Galloway Response
10/30/2024

MISTER CAR WASH

SITE CONSTRUCTION PLANS

VICINITY MAP
SCALE: 1"=600'

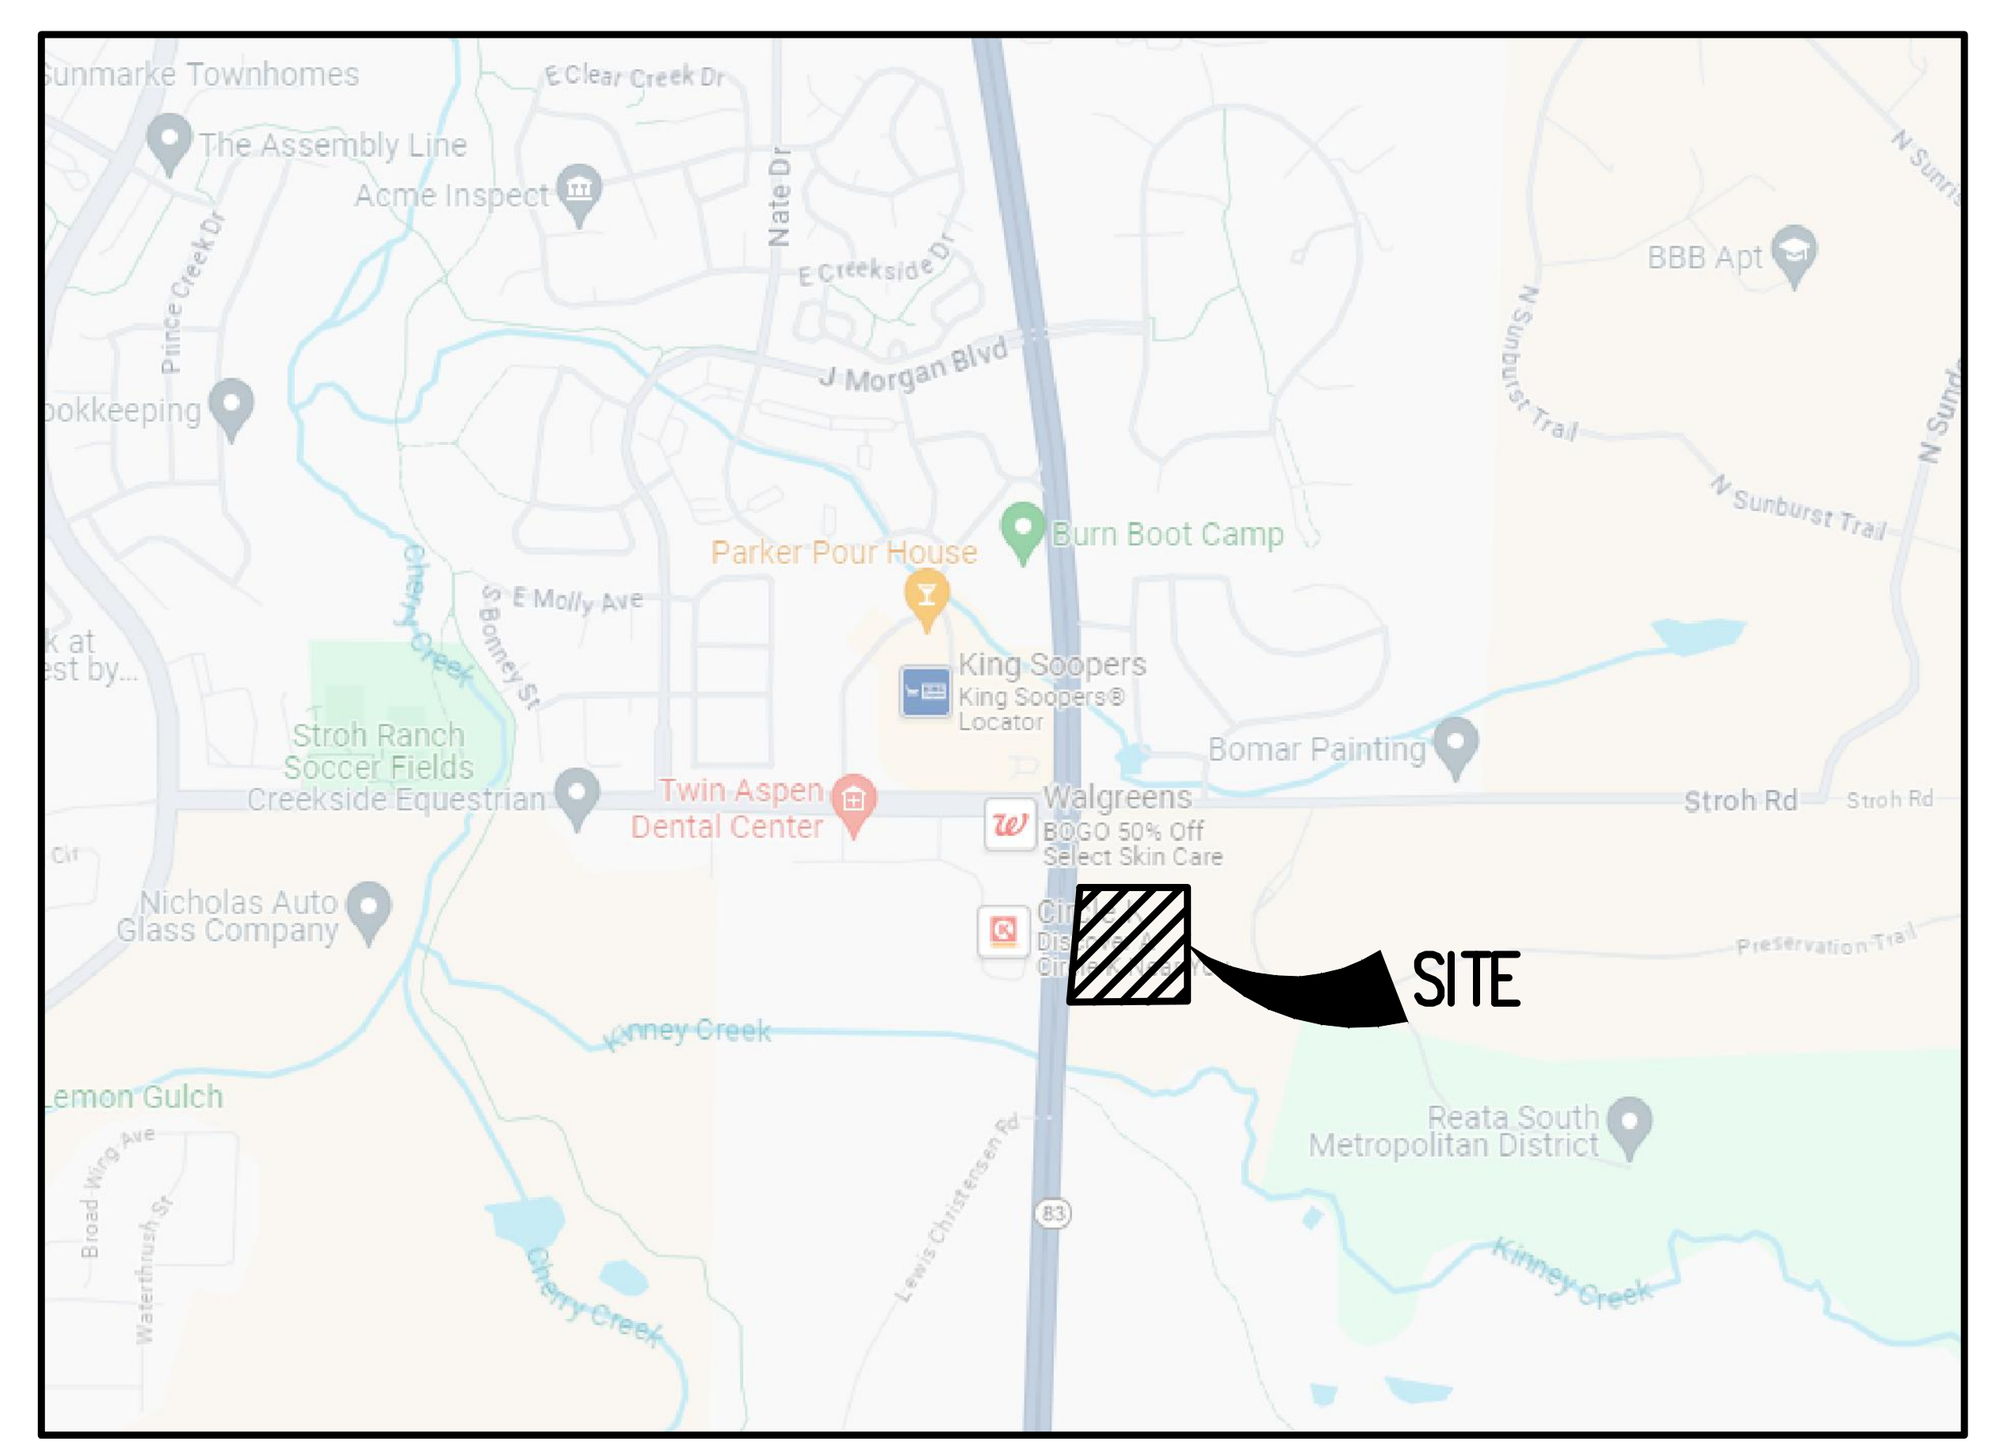
The Vicinity Map shall be at a scale of 1"=2,000' and include location and names of all aerial roadways within one mile of proposed construction. Include any major drainageways in this area.

Vicinity map scale has been revised

GRADING PLAN

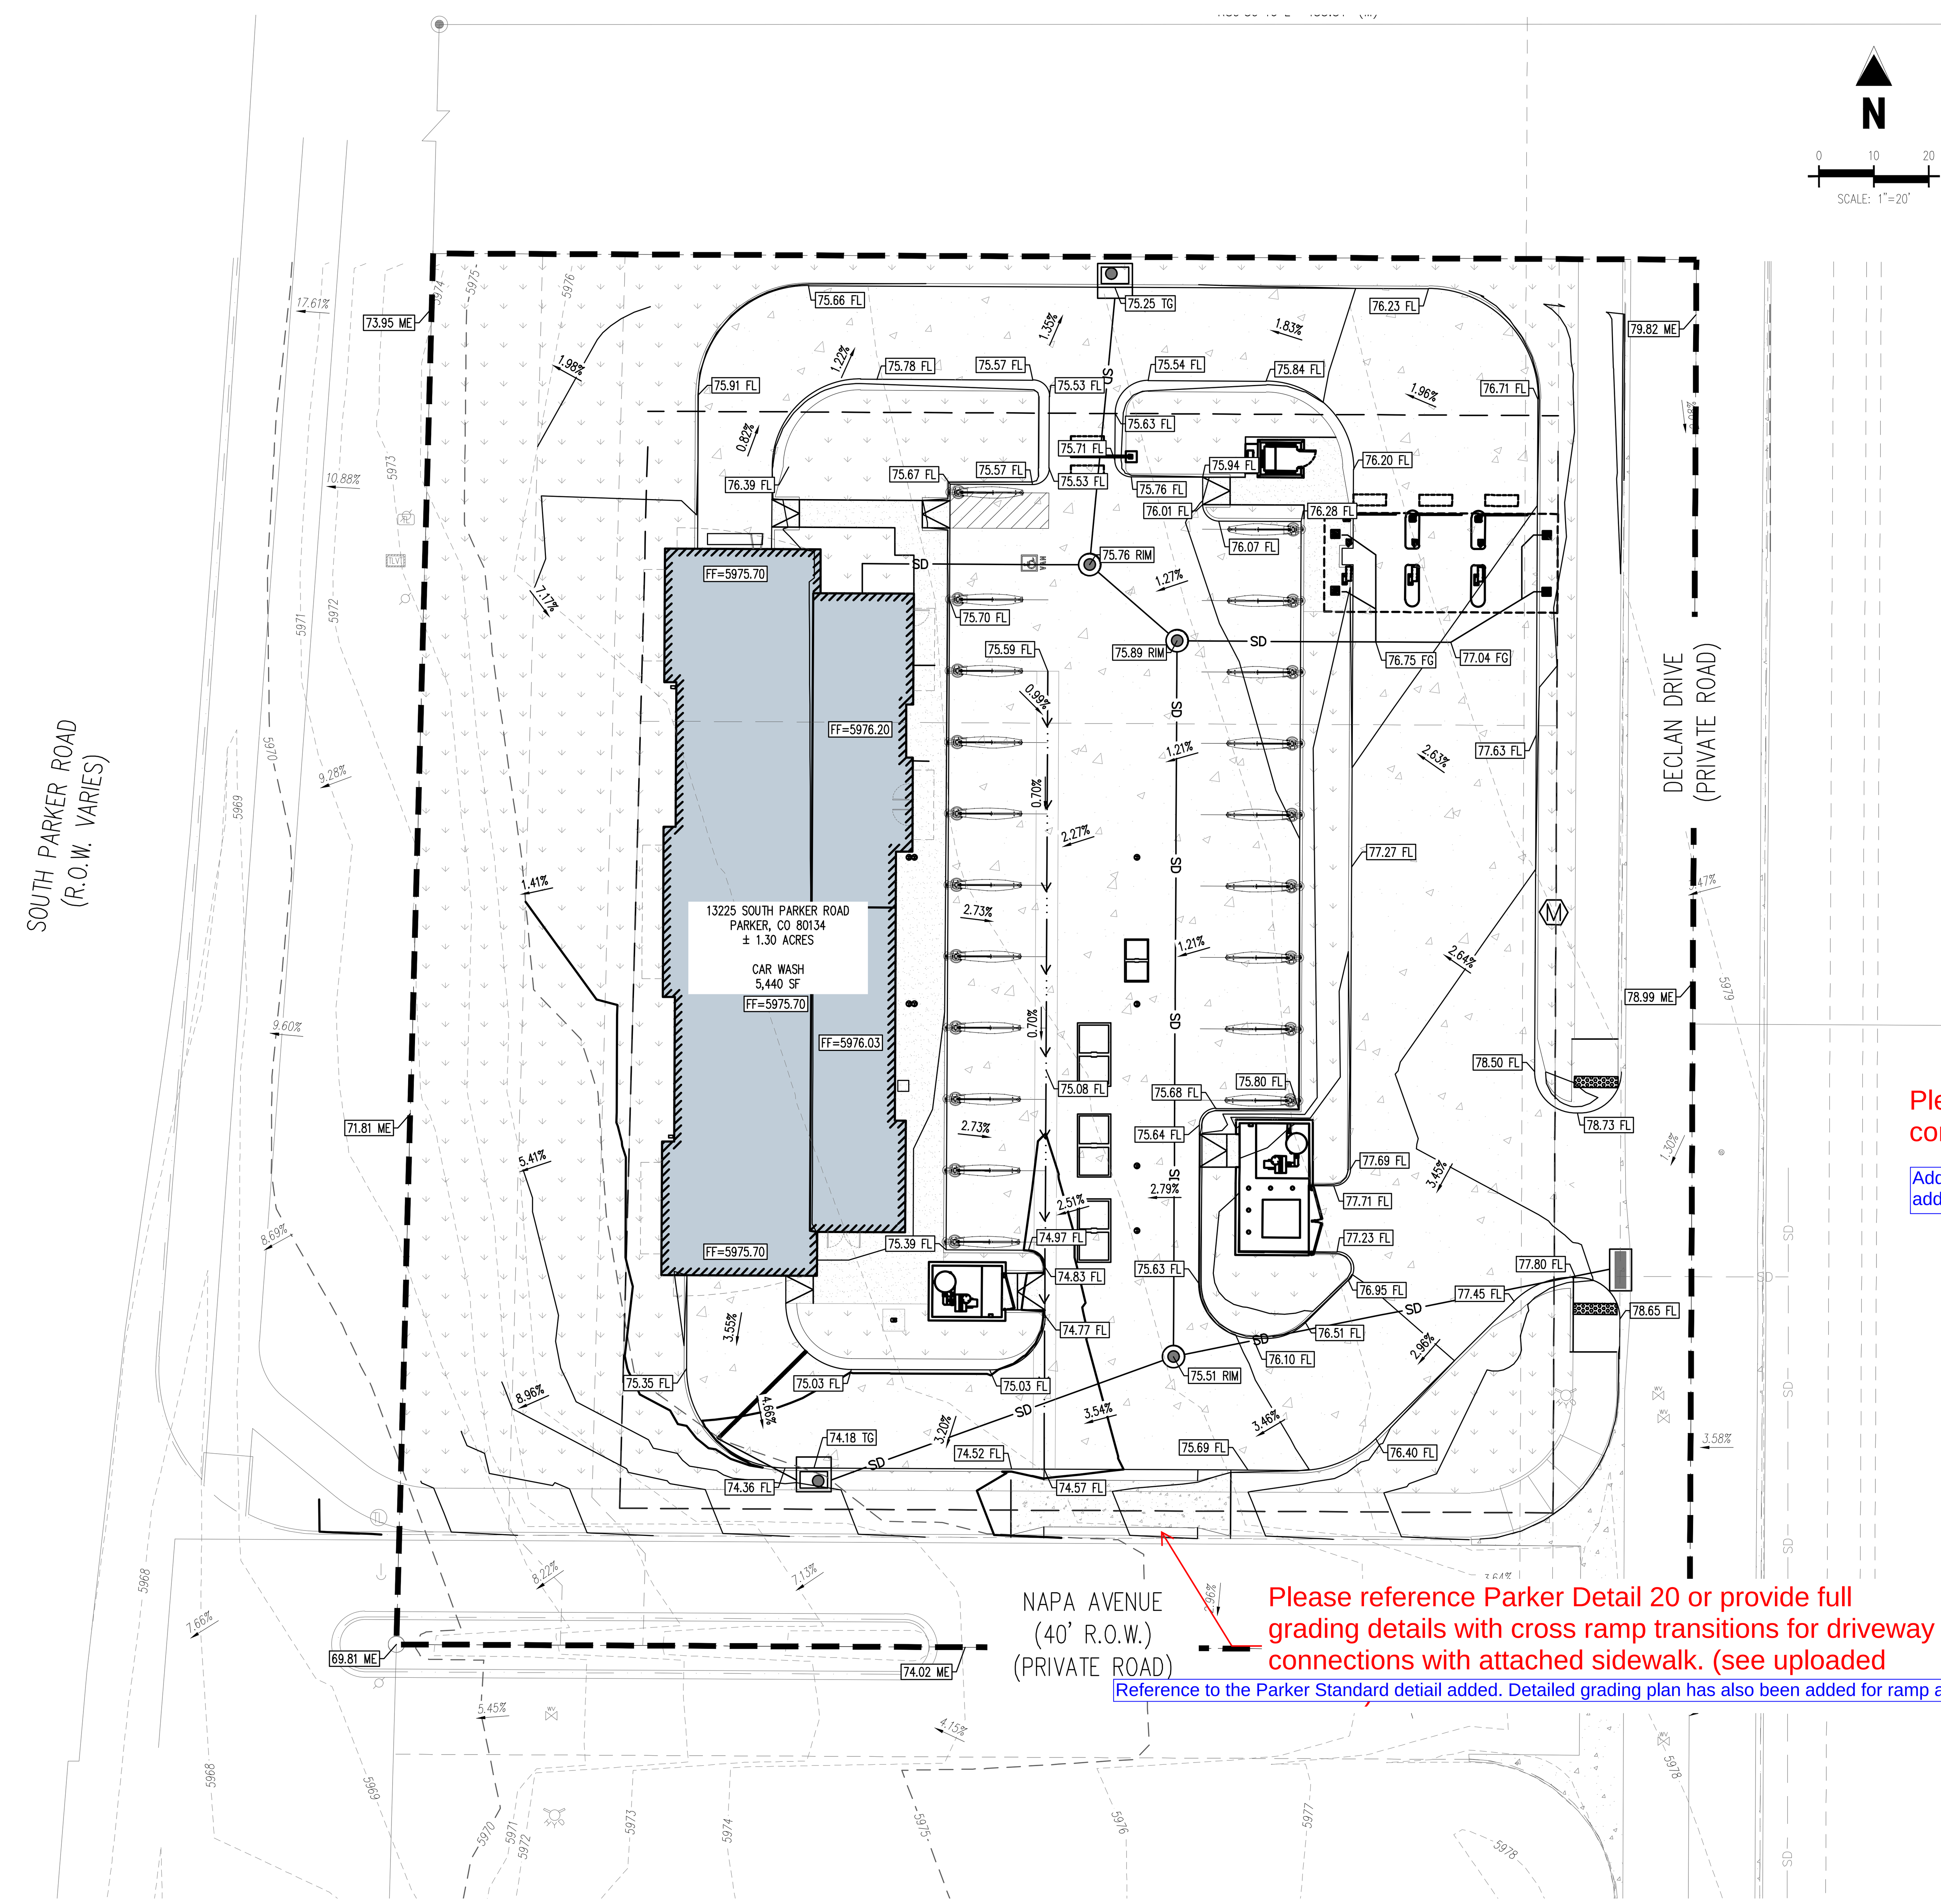
Please include existing and proposed contour labels on all grading plans.

Please reference Parker Detail 20 or provide full grading details with cross ramp transitions for driveway connections with attached sidewalk. (see uploaded

Additional contour labels have been added to the grading plans.

Reference to the Parker Standard detiail added. Detailed grading plan has also been added for ramp areas.

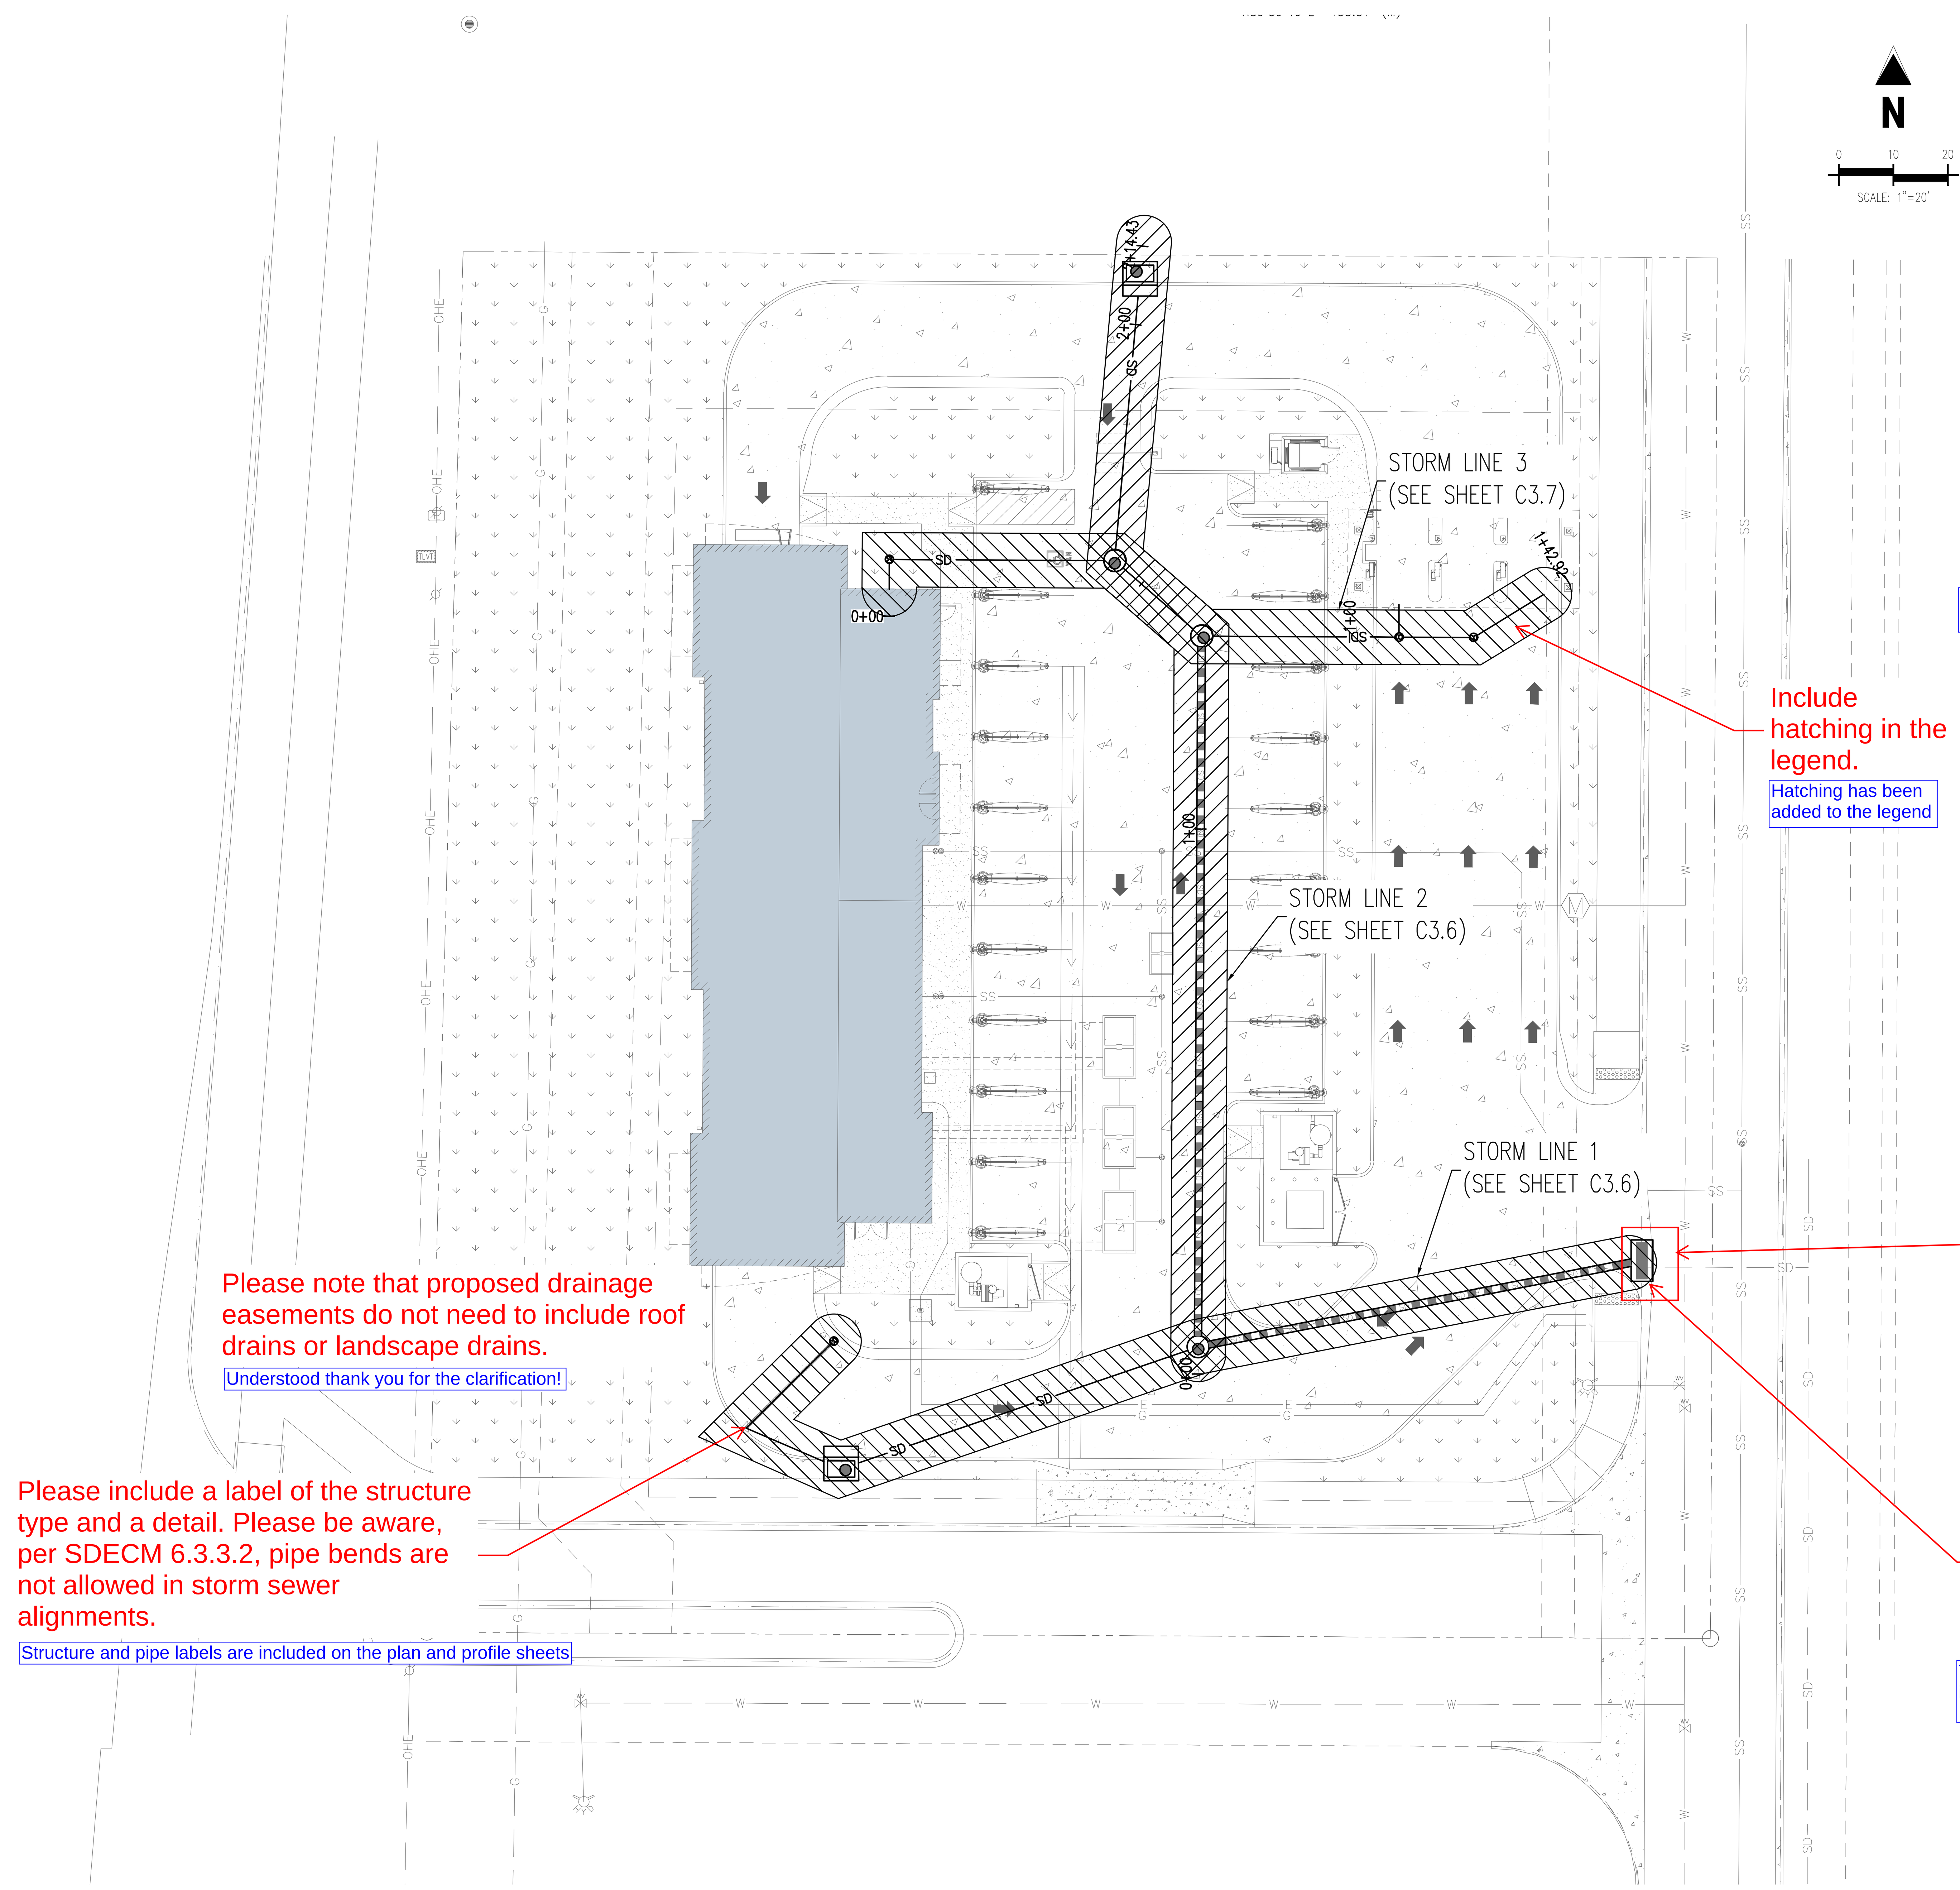
Please dimension and show proposed drainage easements on all Storm Sewer Plans. proposed drainage easements will need to be dedicated by separate document per the Town SDECM. Upon future submittal please provide an exhibit with legal description and name of entity representative/owner to sign.

Proposed drainage easements have been added to all storm plans

Existing and proposed drainage easements have been shown and labeled on all storm plans.
